Approved with Staff Conditions
DESIGN REVIEW & PRESERVATION BOARD

LOCATION: 508 10th Street

PROPOSAL: The applicant proposes to rehabilitate, expand and convert a burned out single family residence into 4 apartment units. The Structure is a Priority Structure on the City's Official Register.

FANNIE GODDARD HOUSE
508 10th STREET

① SITE PLAN

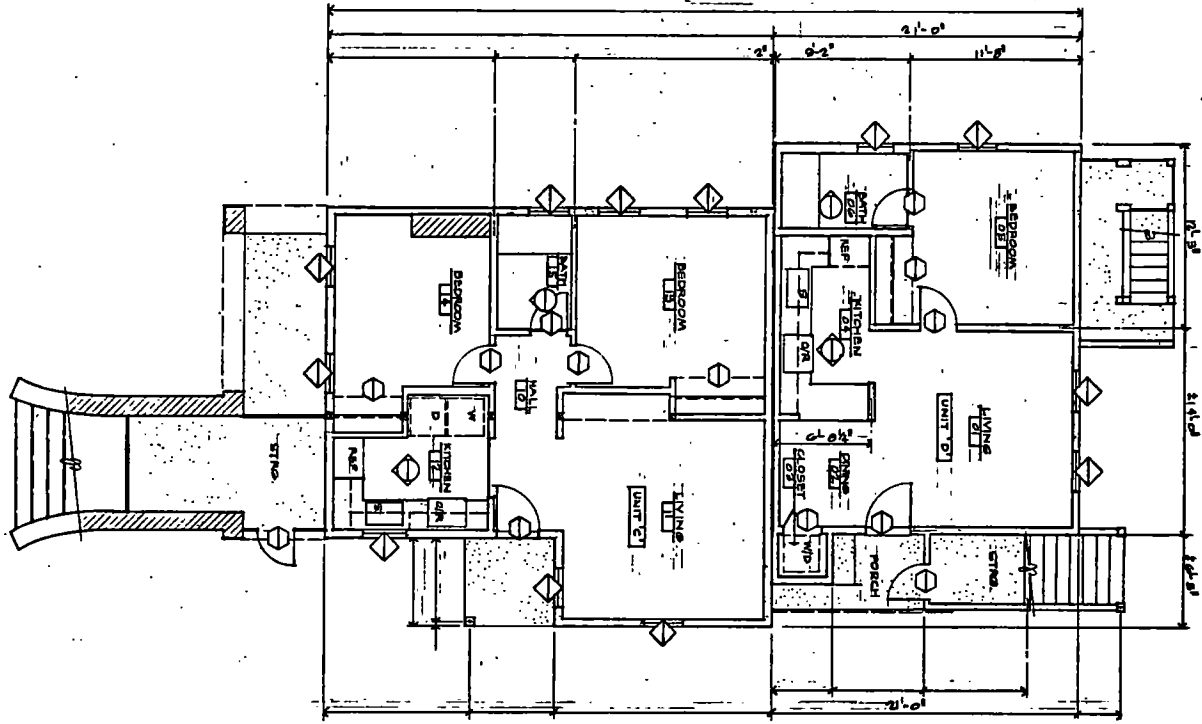
6. Should cross access to the alley not be possible, a driveway to 10th Street would be required with a 24 foot width for two way vehicle movement. In that only a ten foot clearance exists, the applicant would need the City Council's approval to reduce that width requirement of the City Code. Otherwise, the applicant would need to obtain Commission approval for a reduction in the parking requirement or face being only able to convert from the existing single family to two rather than the four units proposed. A variance in the number of parking spaces was not an option recommended by staff.

7. Should a new driveway be provided to 10th Street, the location of landscaping will be of particular importance in mitigating the visual impact of the driveway on the subject structure as well as the Victorian under rehabilitation next door to the south.

1. Changes to existing stairs, porches and porch railings shall be subject to the review and approval of staff.
2. Secondary railings, when necessary for compliance with building code height requirements, shall be subject to review and approval by staff.
3. A detailed landscape and irrigation plan shall be submitted for review and approval by staff. Should a new driveway to 10th Street be needed, particular attention to landscaping in its proximity shall be given.
4. Existing trees and shrubs shall be selectively pruned by qualified personnel.

EXTERIOR ELEVATIONS

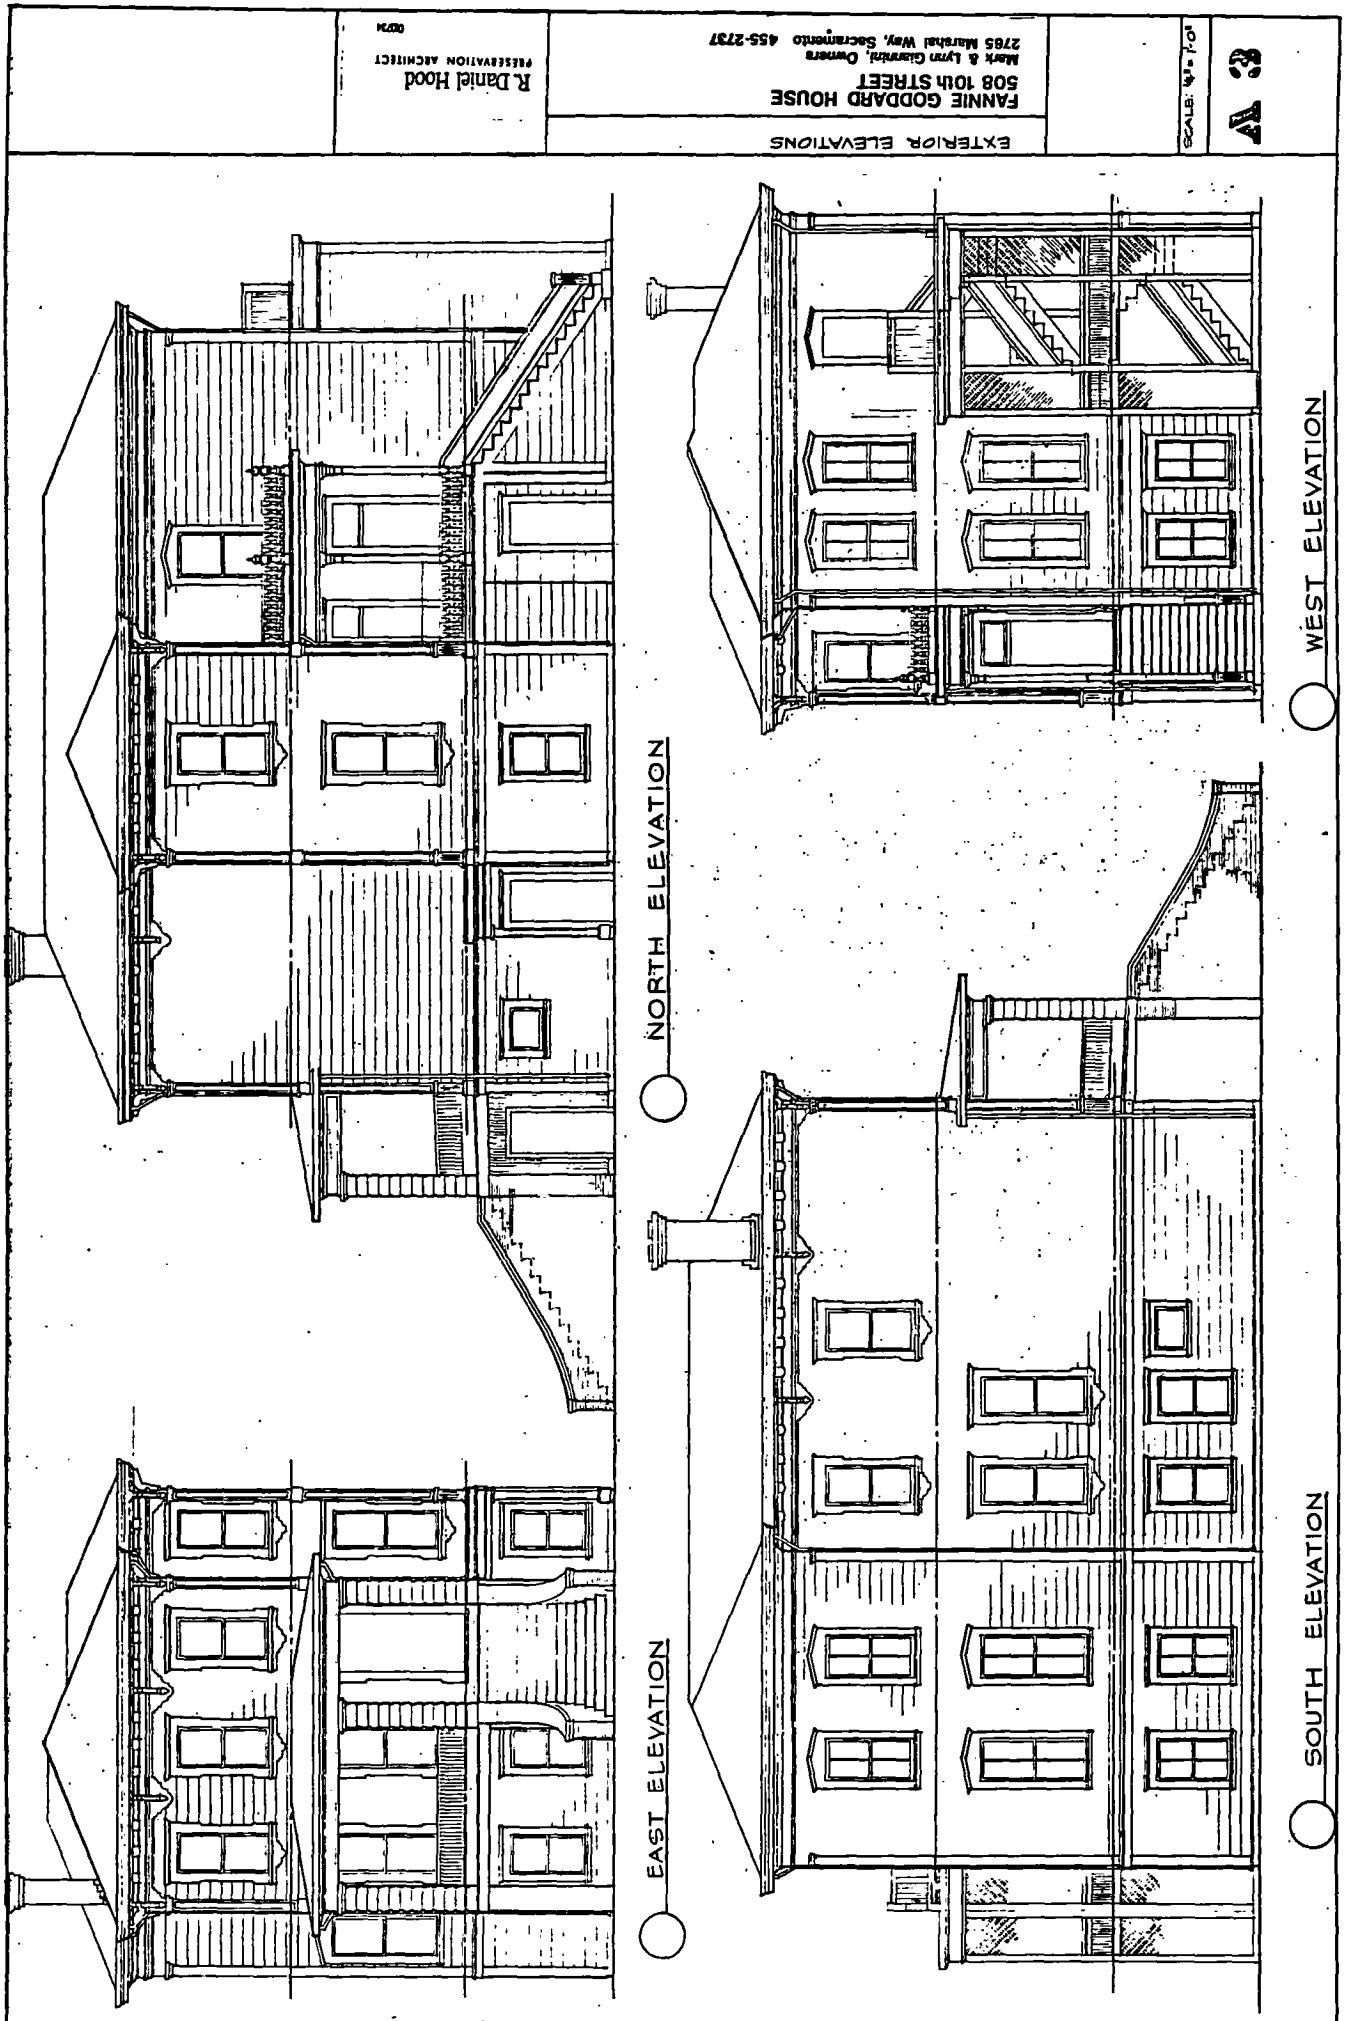
1. Although the front stair and porch are incompatible in design with the basic architecture of the structure, they are part of its historic fabric. Therefore, there is no justification to require restoration to their original appearance. Should the applicant wish to replace the front porch and stairway, however, the design should be subject to staff review and approval.

2. Secondary railing will be necessary on front and side porches for compliance with building code requirements. The designs should be subject to staff review and approval.

3. A vent chimney is proposed to be removed from a valley location between two roof surfaces. Due to its poor location, water damage and dry rot had resulted in the past.
